## Technical Memorandum

**SUBJECT:** Review of Wickson Creek SUD Well 9 Simsboro Aquifer Evaluation Report

**DATE:** May 5, 2023

Figure 2. Analytical Simulated Drawdown Effects After Proposed Well 9 Pumping of 1,939 ac-ft/yr for 1-Year

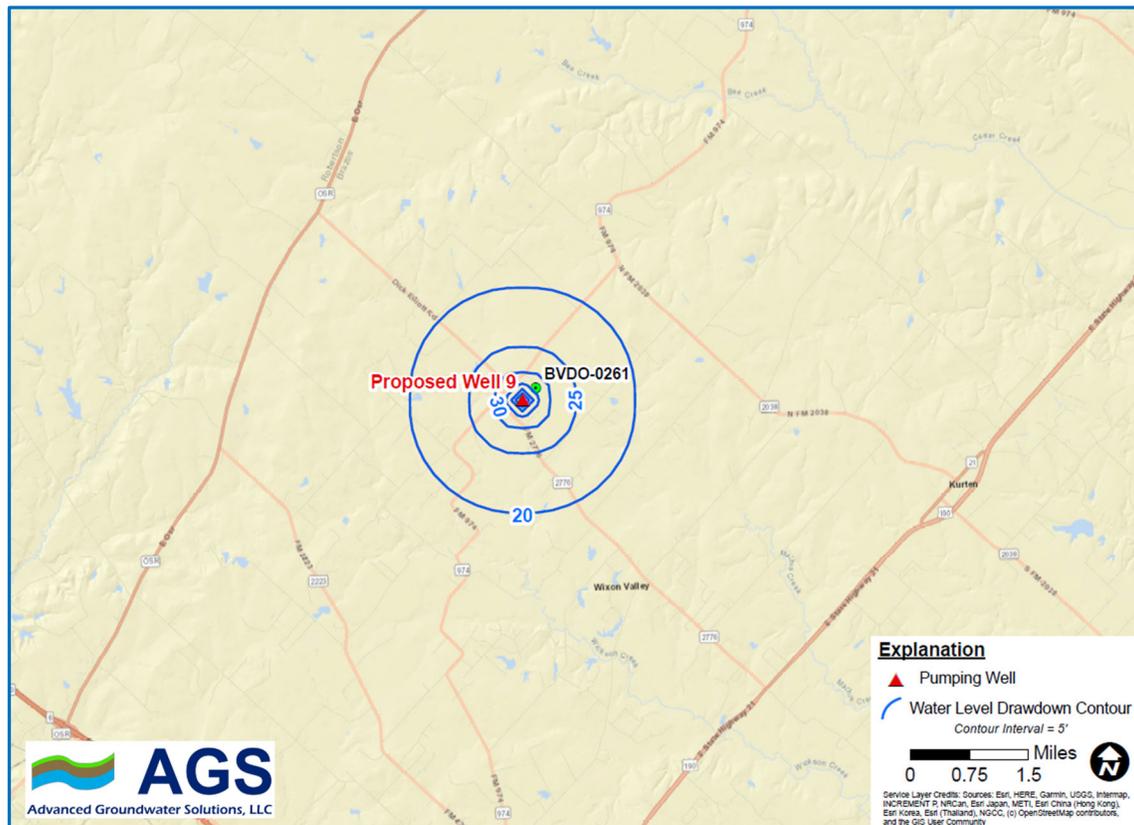
AGS estimated the drawdown at the pumping well using a Theis analytical model and estimated the drawdown at proposed Well 9 and at Wickson Creek SUD Well 8 (BVDO-0261). A transmissivity value of 46,368 gallons per day per foot (gpd/ft) and storativity value of 0.000123 from the Central Portion of the Sparta, Queen City and Carrizo-Wilcox Aquifers GAM Simsboro model cell corresponding to the proposed Well 9 location were used in the analytical simulation.

AGS simulated about 73 feet and 79 feet of drawdown at proposed Well 9 after pumping 1,939 ac-ft/yr for 1-year and 10-years, respectively. Resulting drawdown estimates of about 31 feet (1-year) and 37 feet (10-years) were observed at Wickson Creek SUD Well 8 (BVDO-0261). Figures 2 and 3 below show drawdown contours from the analytical model simulation.

Figure 4. Projected GMA 12 2021 Planning Cycle DFC Water Level Decline at Proposed Well 9.

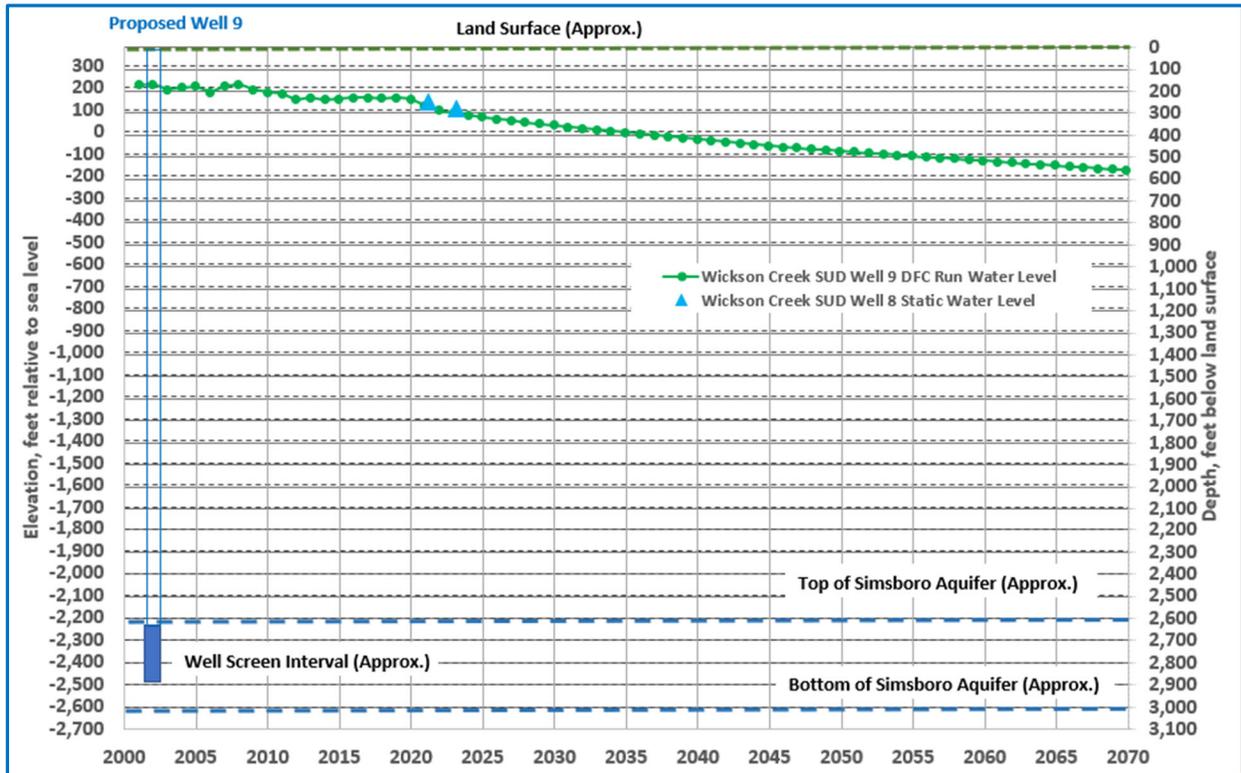
As a way of evaluating potential long-term estimated water level decline at the proposed Well 9, AGS plotted the simulated water level decline at the proposed well location based on the 2021 Groundwater Management Area 12 (GMA 12) Desired Future Conditions (DFC)/Modeled Available Groundwater (MAG) projections for the Simsboro Aquifer as shown in Figure 4 below. The water level projections shown in Figure 4 are from the TWDB approved DFC/MAG run known as GMA 12 “S-19”, but do not include the local impacts from the proposed well, nor do they include all of the pumping from the Simsboro Aquifer that has been permitted in the area in the past year. The DFC run includes pumping estimates from the Groundwater Conservation Districts in GMA 12 as of about December 2021 that yield DFCs so that the TWDB can estimate the MAG. The detailed assumptions for the DFC simulation can be found in the GMA 12 Explanatory Report (Daniel B. Stephens & Associates and others, 2022) and documentation of the TWDB MAG run can be found in GAM Run 21-017 MAG: Modeled Available Groundwater for the Aquifers in Groundwater Management Area 12 (Shi and Harding, 2022).

The graph illustrates the relationship between the land surface, estimated static water level through time, and the estimated top and bottom of the Simsboro Aquifer at the proposed Well 9 location. Static water level measurements are also shown on Figure 4 for Wickson Creek SUD Well 8 (BVDO-0261).

Available drawdown in wells in the Simsboro Aquifer will decline over time based on the DFC simulation. Although not evaluated or discussed in detail herein, these levels of water level decline in wells and artesian head decline in the aquifer will have some impact on vertical leakage, intercepted discharge, reduction in confined and unconfined storage, and potential flow directions in the aquifer.

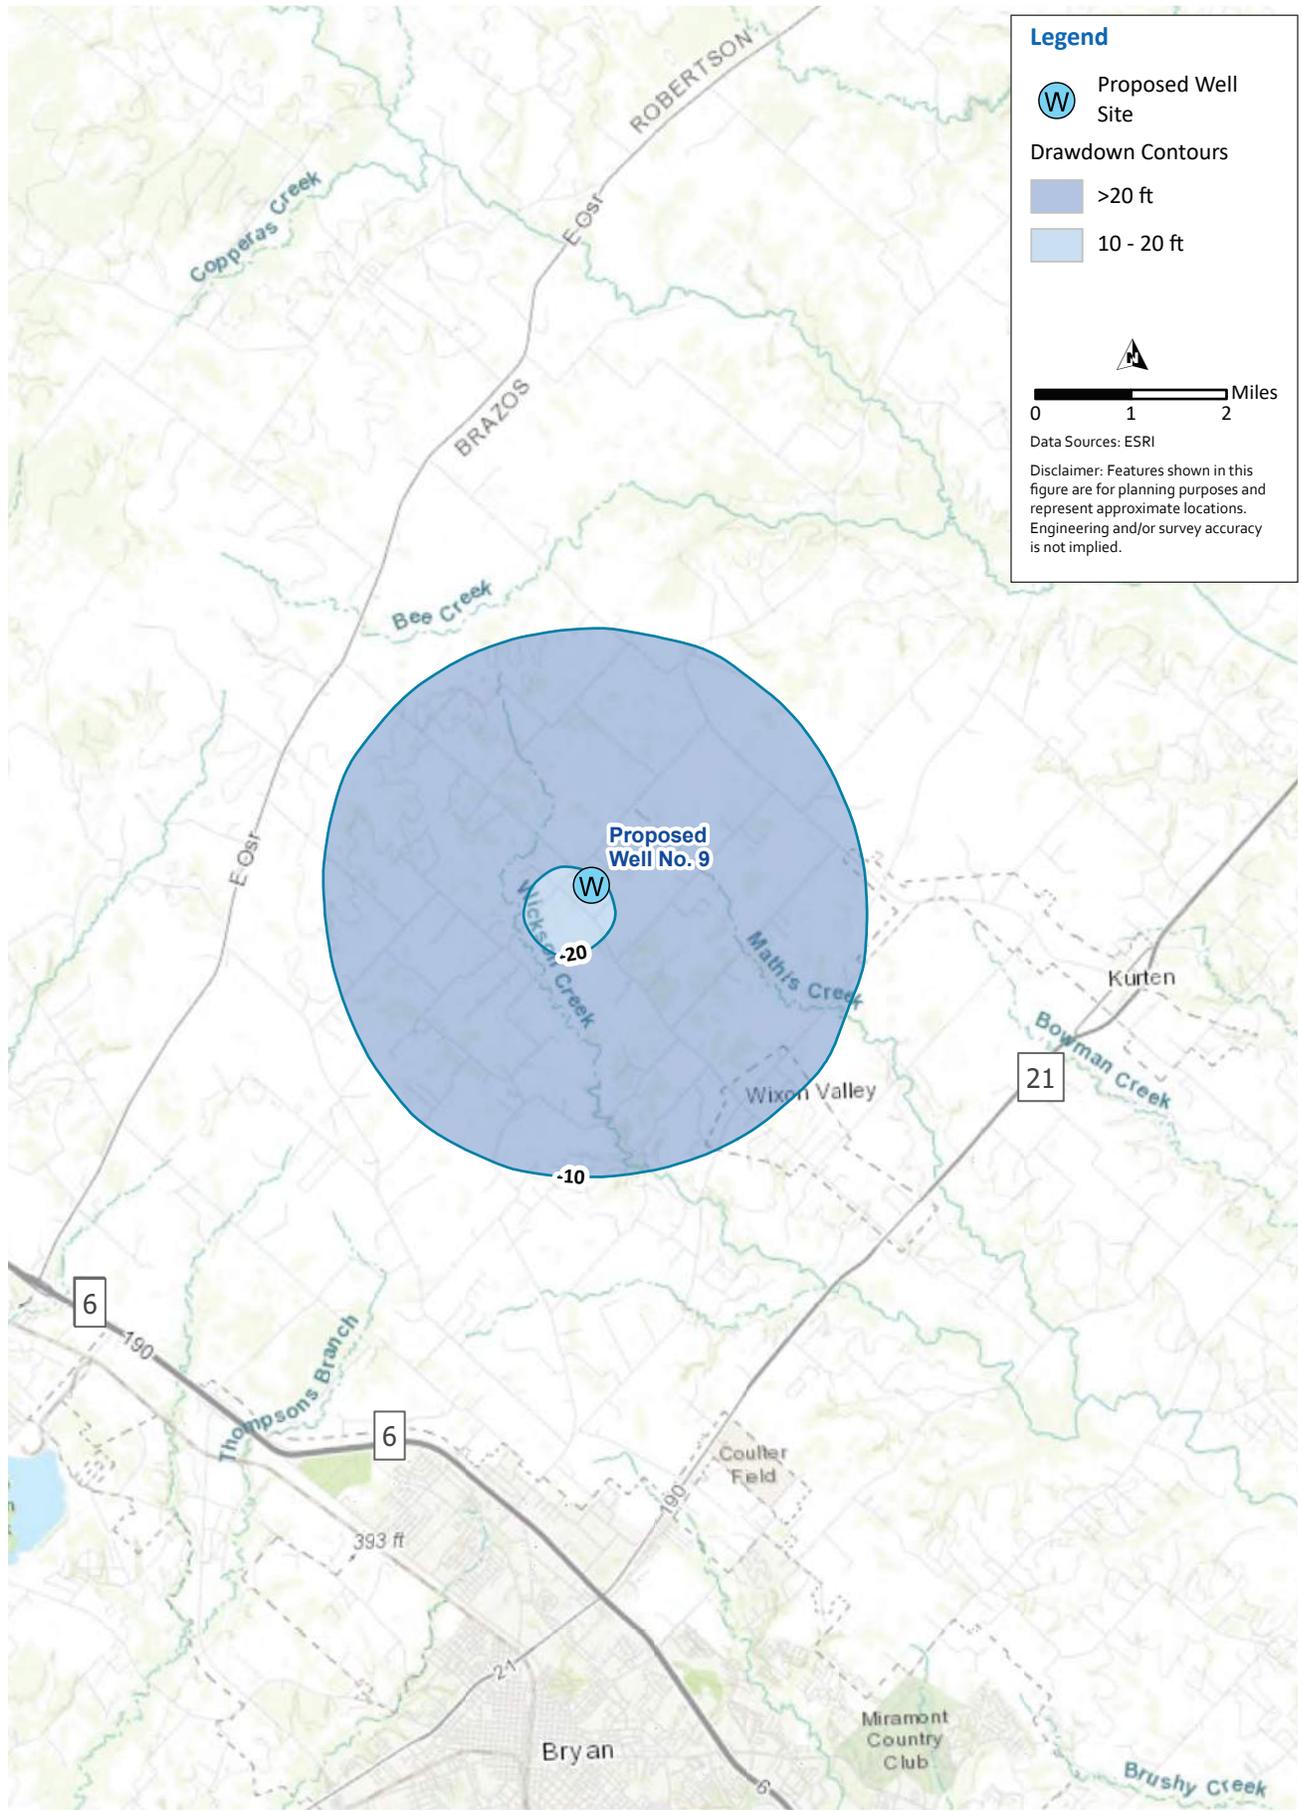
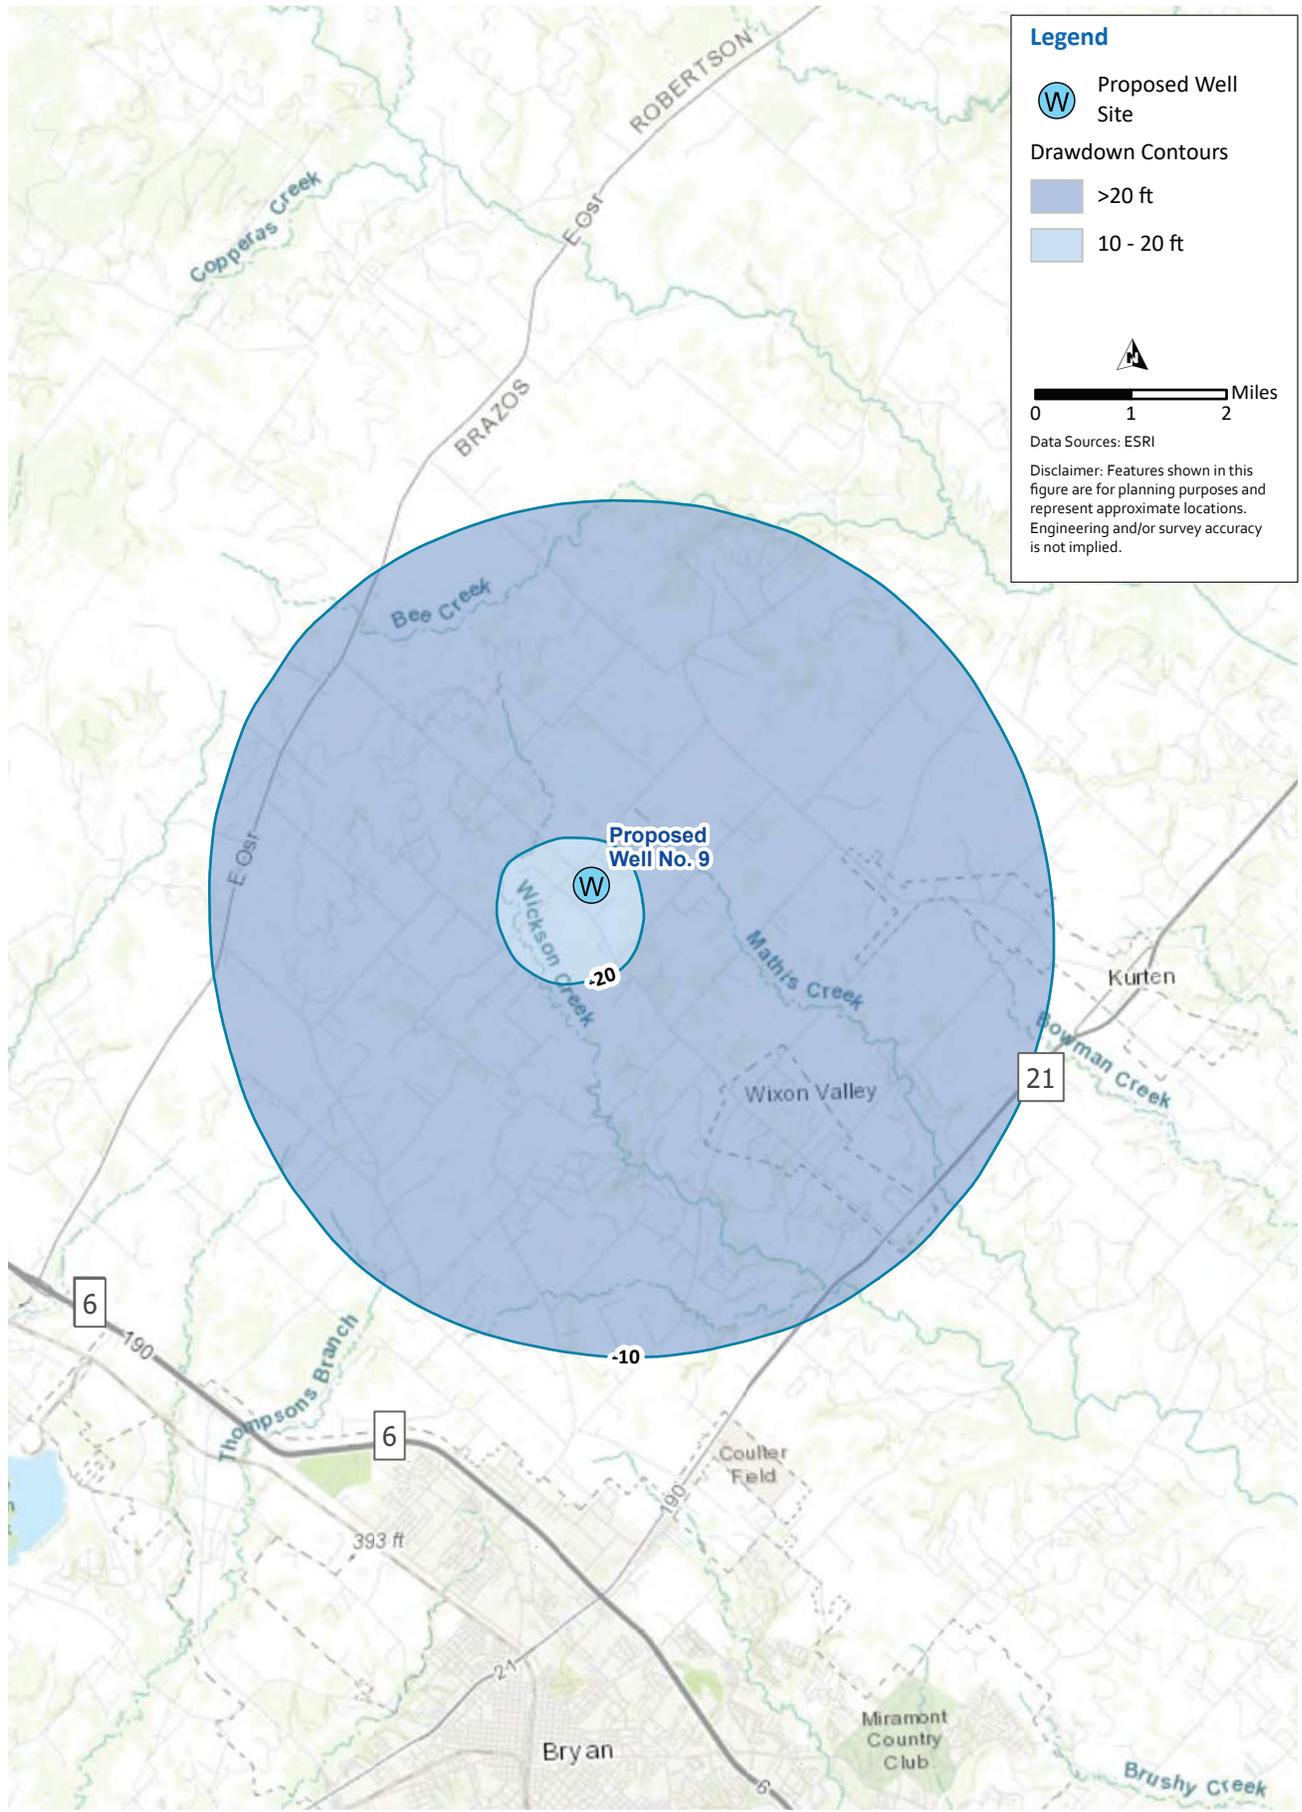
Carollo used the TWDB Central Portion of the Sparta, Queen City and Carrizo-Wilcox Aquifer GAM to estimate drawdown that results from continuously pumping the proposed well at 1,939 ac-ft/yr for 1-year and 10-years. Carollo isolated the pumping effects of proposed Well 9 by evaluating the differences in simulated water levels between the historical baseline scenario and the baseline scenario plus the proposed Well 9 pumping. AGS considers this to be a reasonable approach.

A copy of the Carollo 1-year and 10-year GAM simulated interference drawdown illustrations from the AER (Carollo Figures 1.4 and 1.5) are attached to this memorandum. Table 1.3 in the AER shows GAM simulated 1-year and 10-year drawdown estimates at Wickson Creek SUD Well 8 (BVDO-0261), which is the only BVGCD permitted and registered Simsboro well within 1-mile of the proposed well. BVGCD Rule 8.4(b)(7)(B)(3) requires 1-year and 10-year drawdown estimates for BVGCD permitted and registered wells completed in the same aquifer as the proposed well within a 5-mile radius. Wickson Creek SUD Well 1 (BVHU-0027) is the only additional Simsboro Aquifer well permitted or registered with BVGCD within 1-to5-miles of proposed Well 9 and is discussed in a subsequent section of this memorandum.

The finalized Well 9 annual permit allocation is 1,879 ac-ft/yr, which is less than the 1,939 ac-ft/yr used in the GAM simulations. The simulated pumping effects of proposed Well 9 pumping 1,879 ac-ft/yr would be slightly less than what is shown in the AER with the proposed well pumping

1,939 ac-ft/yr. AGS did not see a need to update the proposed Well 9 GAM simulation since the requested Well 9 permit allocation was decreased.

AGS performed GAM simulations to verify the Carollo GAM simulations and results show drawdown estimates that are consistent with results presented in the AER. AGS obtained similar drawdown estimates at Wickson Creek SUD Well 8 (BVDO-0261). Wickson Creek SUD Well 1 (BVHU-0027) is the only additional Simsboro Aquifer well permitted or registered with BVGCD within 1-to 5-miles of proposed Well 9. GAM estimated drawdown values of about 13 feet and 16 feet were simulated at Wickson Creek SUD Well 1 (BVHU-0027) after 1-year and 10-years of pumping proposed Well 9 at 1,939 ac-ft/yr.
